City of Corpus Christi

Meeting Agenda Planning Commission

Wednesday, October 14, 2020

**TECHNICAL REVIEW PLAT REQUIREMENTS
REGULAR PLANNING COMMISSION MEETING
OCTOBER 14, 2020**

Plat of
Riverbend Subdivision
Unit 3

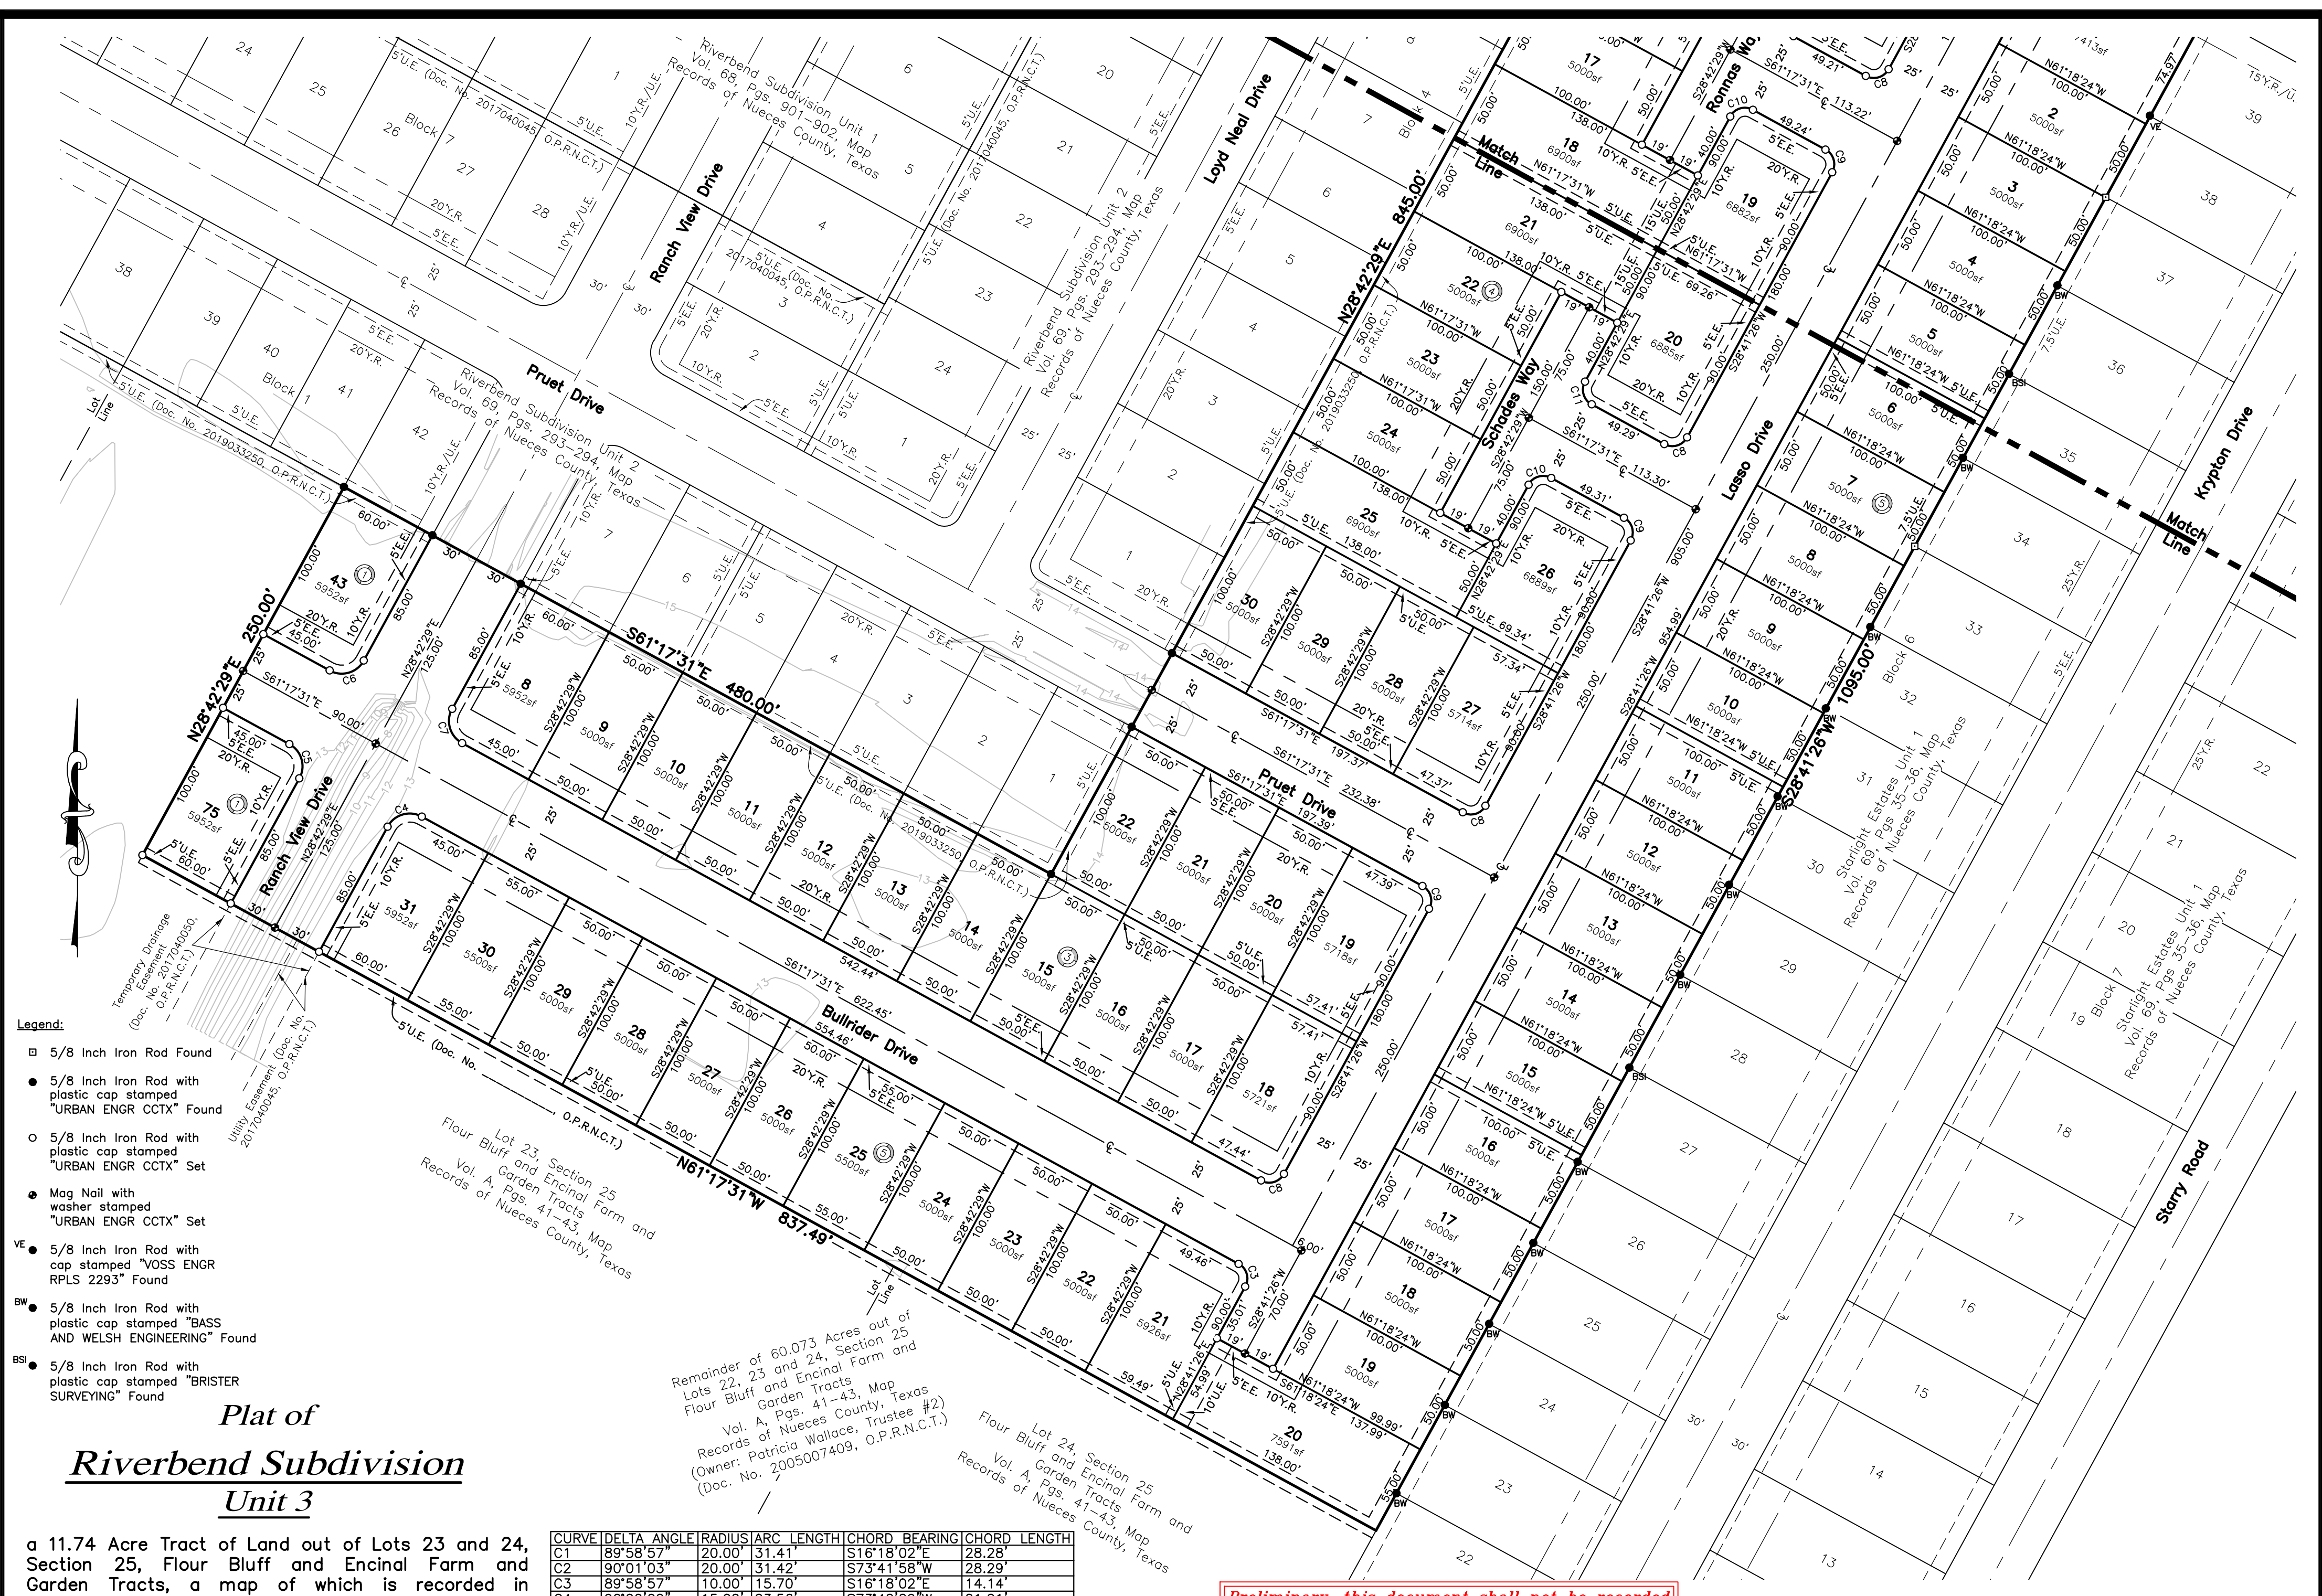
GIS						
No.	Sheet	Comment	Applicant Response	Staff Resolution	Applicant Response	Staff Resolution
1	Plat	The plat closes within acceptable engineering standards.	Understood	Resolved.		
2	Plat	Label street names on t-heads coming off of Lasso Drive as listed on the preliminary plat.	Labels have been added	Resolved.		
3	Plat	Include 25' right of way easement on Yorktown Blvd. (doc#2005040990)	Right of way label has been added	Resolved.

4	Plat	Provide curve data for platted area.	Has been added	Unresolved- Curve data on third page is overlapped by legend and north arrow. Please correct in order to make data legible.	Correction has been made	Resolved.
5	Plat	Label streets on adjacent subdivisions (North west section of page 2)	Labels have been added	Resolved.		
6	Plat	Provide dimensions for both sides of Yorktown Boulevard centerline.	Labels have been added	Resolved.		
7	Plat	Correct the spelling of street Bullrider Drive (as listed on preliminary plat)	Has been corrected	Resolved.		
8	Plat	Correct the spelling of adjacent subdivision *Starlight Estates	Has been corrected	Resolved.		
9	Plat	On location map, correct the spelling of Rancho Vista Blvd.	Has been corrected	Resolved.

No.	Sheet	Comment	Applicant Response	Staff Resolution	Applicant Response	Staff Resolution
1	Plat	Provide a 5' EE label for Blk. 5 frontage.	Correction has been made	Addressed		
2	Plat	Provide a 5' UE for rear of Lots 21-31 in Blk. 5, and Lots 43 and 75, Blk. 1.	Labels have been added			
3	Plat	Provide a 5' EE label for Lots 18 & 19, Blk 3.	Label has been added			
4	Plat	All Lots to have 20' YR, in particular Lots 15-17 and 22-24, Blk 4	Correction has been made			
5	Plat	Provide a UE label for Lots 21-25 & 30, Blk 4. Indicate document number.	Correction has been made	Not addressed.	label has been added	Addressed
6	Plat	Provide YR, EE and UE labels for Lots 1-5, Blk 5.	Labels have been added	Not addressed.	labels have been added	Addressed
7	Plat	Provide a minimum 15' UE for all looping water lines.	Understood	Addressed		
8	Plat	Label Pruet Dr. on Riverbend Unit 2.	Label has been added			
9	Plat	DS Engineer is Jalal Saleh, P.E.	Has been corrected

10	Plat	Provide flood plain boundaries.	Property is entirely in Zone B There are no boundaries to depict			
11	Plat	Provide document number for offsite easment by separate recording.	Will Provide prior to recordation	To be addressed prior to recordation.

12	Plat	Coordinate offsite easement Doc #2019033250 in relation to easements dedicated by this plat. Provide new labels for Lots 15-18, Blk 3. Remove labels on Block 3 and 4 and replace with easement by separate recording.	Correction has been made	Not addressed.	labels have been revised according to recorded document.	Addressed
13	Plat	Water Pro-rata: 357.16 LF x \$10.53= \$3,760.89	Understood	To be addressed prior to recordation.		
14	Plat	Waste water Pro-rata: 357.16 LF x \$12.28= \$4,350.12	Understood	To be addressed prior to recordation.		
15	Plat	Water Distribution System acreage fee: 11.74 acres x \$719.00/acre = \$8,441.06	Understood	To be addressed prior to recordation.		
16	Plat	Wastewater System acreage fee: 11.74 acres x \$1,571.00/acre = \$18,443.54	Understood	To be addressed prior to recordation.

No.	Sheet	Comment	Applicant Response	Staff Resolution	Applicant Response	Staff Resolution
1		All hammer heads must conform to the City current hammer Head design, use the following hyperlink to access the City current hammer Head design: https://www.cctexas.com/sites/default/files/udc-informal-staff-report-written-int-hammerhead-design.pdf	Hammer Heads shall comply with Previously approved Hammer Head configuration Per Preliminary Plat.	Addressed		
2	Utility Plan	.A proposed street lighting layout will be required for review by Traffic Engineering. This item is required prior to Plat Recordation	Understood	To be addressed prior to recordation.		
3		The water line on Lasso must be 8" in diameter.; no dead end mains allowed.	There is an 8" Line in Ranch View. Why is another Parallel 8" Line need two blocks away?Preliminary plat has been approved	Addressed		
4	Utility Plan	Public Improvements and development fees shall be required prior to Final plat Recordation. Public Improvements shall meet all city master plans and city standards. Public improvement plans must include a 5' wide sidewalk along Yorktown.	See Previous Sidewalk Comment	To be addressed prior to recordation.

5	Utility Plan	The Water Main at the South west end of Ranch View Drive must extend to the Property limit.	Understood, I assume by property limit they are refering to final plat boundary.	To be addressed prior to recordation.		
6	Informa tional	See Utilities Department Comments hereafter.	Understood	Addressed

4		As mentioned on Plat Review for "20PL1009 Starlight", additional homes are being proposed to a subdivision which only has one external access points to an existing network. Yorktown Boulevard is the only existing access point for this subdivision.	Riverbend subdivision proposes 3 points of access to Yorktown and one to South through Starlight.			
5		Submit a street lighting plan for review with Traffic Engineering prior to recordation of plat.	Understood	To be addressed with Public Improvement plans prior to recordation.

GAS						
No.	Sheet	Comment	Applicant Response	Staff Resolution	Applicant Response	Staff Resolution
1	Plat	Request 10' U.E. between lots 18,19, Blk. 4 (5' each side). Request 10' U.E. between lots 5 & 6, BLK. 5 (5' each side)	Easements have ben added to match approved preliminary plat	Addressed.		
2	Plat	Request 5' U.E. on lot 25, Blk. 4. Request 10' U.E. between lots 10 &11, Blk. 5 and 10' U.E. between lots 15 & 16, Blk. 5 (5' each side)	Easements have ben added to match approved preliminary plat	Addressed.

PLAT OF
ROYAL CREEK ESTATES UNIT 8
AN 10.544 ACRE TRACT OF LAND, MORE OR LESS, A PORTION OF LOTS 10, 22, AND 23,
SECTION 22, FLOUR BLUFF AND ENCINAL FARM AND GARDEN TRACTS, A MAP OF WHICH IS
RECORDED IN VOLUME "A", PAGES 41 - 43, MAP RECORDS, NUECES COUNTY, TEXAS
CORPUS CHRISTI, NUECES COUNTY, TEXAS

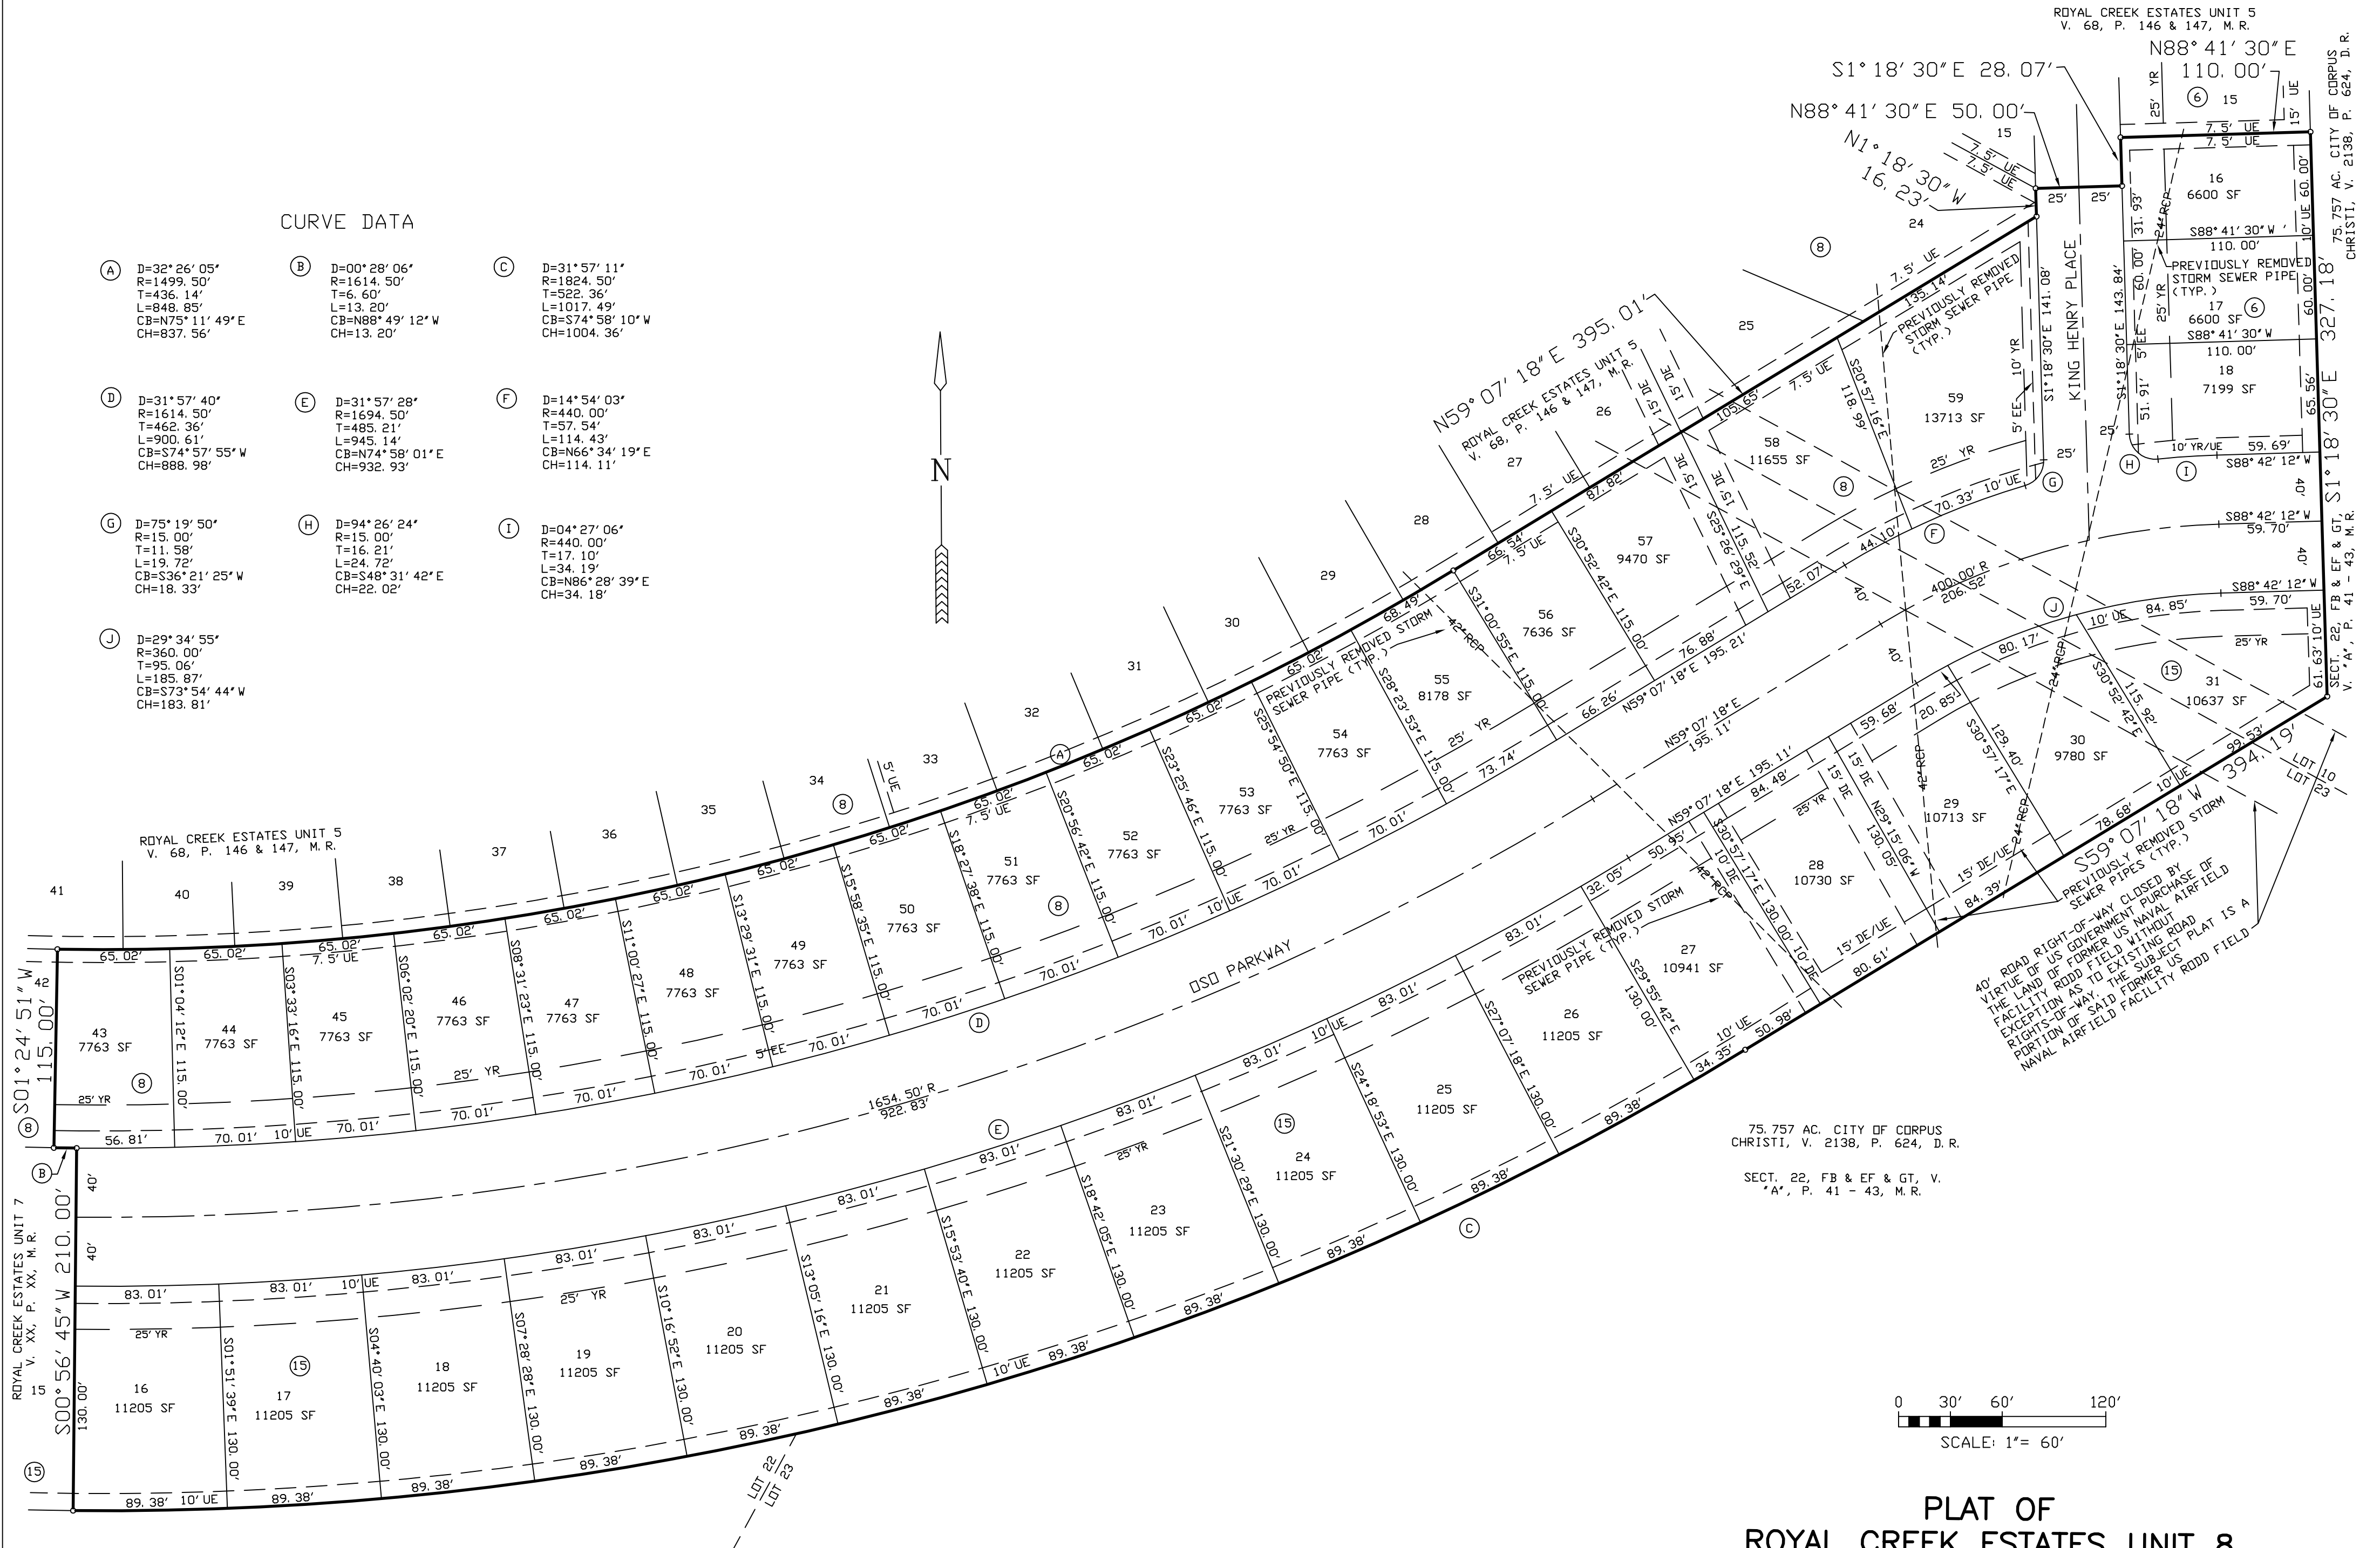
GIS						
No.	Sheet	Comment	Applicant Response	Staff Resolution	Applicant Response	Staff Resolution
1	Plat	The plat closes within acceptable engineering standards.	Ok.	Resolved		
2	Plat	No special characters (dashes, apostrophes, periods, slashes, tildes, etc.) may be used in addresses. (*King Henry Place)	Corrected.	Resolved

LAND DEVELOPMENT						
No.	Sheet	Comment	Applicant Response	Staff Resolution	Applicant Response	Staff Resolution
1	Plat	Provide printed name of Lien Holder on ownership and Lien Holder certificate.	Don't know name yet.	To be addressed prior to recordation		
2	Plat	Jalal Saleh, PE is the DS Engineer	Corrected.	Addressed.		
3	Plat	Al Raymond III, AIA is the Secretary for Planning Commission and Jeremy Baugh is the Planning Commission Chairman	Corrected.	Addressed.		
4	Plat	Remove Utilities and reference from plat that were previously removed. Place on Utility plan.	Previously removed storm sewer pipes need to be shown for foundation design	Addressed, to be left as is on plat.		
5	Plat	Oso Parkway to require 10' easement. Replace the 5' EE to a 10' UE along the frontage to Oso Parkway.	Done.	Addressed.

6	Plat	Verify the lot width will be able to accommodate the 150' Driveway spacing as per the Oso Parkway Plan. Provide a plat note that indicates that lots may be required to share driveways to meet the 150' spacing regulation.	NOT A REQUIREMENT PURSUANT TO CONVERSATION BETWEEN MOSES, GENE AND BILL (from comments when plat was approved previously)	Addressed.		
7	Plat	Water Distribution System Acreage fee – 36 lots x \$182.00/acre = \$6,552.00		To be addressed prior to recordation		
8	Plat	Wastewater System Lot fee – 36 Lots x \$393.00/lot = \$14,148.00		To be addressed prior to recordation		
9	Plat	Provide recording reference for the 30' Drainage Easement crossing between lots 57 and 58 and between lots 27 and 28.	There is no recording information. The previous DE was temporary and will expire with recording of this plat	Addressed. Dedicated DE as per this plat.

DEVELOPMENT SERVICES ENGINEERING						
No.	Sheet	Comment	Applicant Response	Staff Resolution	Applicant Response	Staff Resolution
1		Public Improvements Plans are required; submit a pdf copy of proposed public improvements along with a title sheet to PublicImprovements@cctexas.com for review and approval; this item is required prior to Final Plat Recordation. UDC 8.1.3.A	Ok.	Addressed: A cursery review will be performed.		
2	Plat	Add the following note "all driveways shall conform to access management standards outlined in Article 7 of the UDC".	See Land Development 6 above.	Addressed		
3		Provide the pavement design per the attached Infrastructure Design Manual (IDM).	The pavement design is the same as used for Oso Parkway elsewhere in the city , 4"HMAC, 11" CLB & 8" LSS	Addressed

4	Plat	Remove "the previously removed Storm" and remove the dashed lines for the same.	Previously removed storm sewer pipes need to be shown for foundation design	Addressed		
5		If any of the items above was resolved and approved through prior discussions / preliminary plat / etc., provide documentation.	See Land Development 6 above.	Addressed
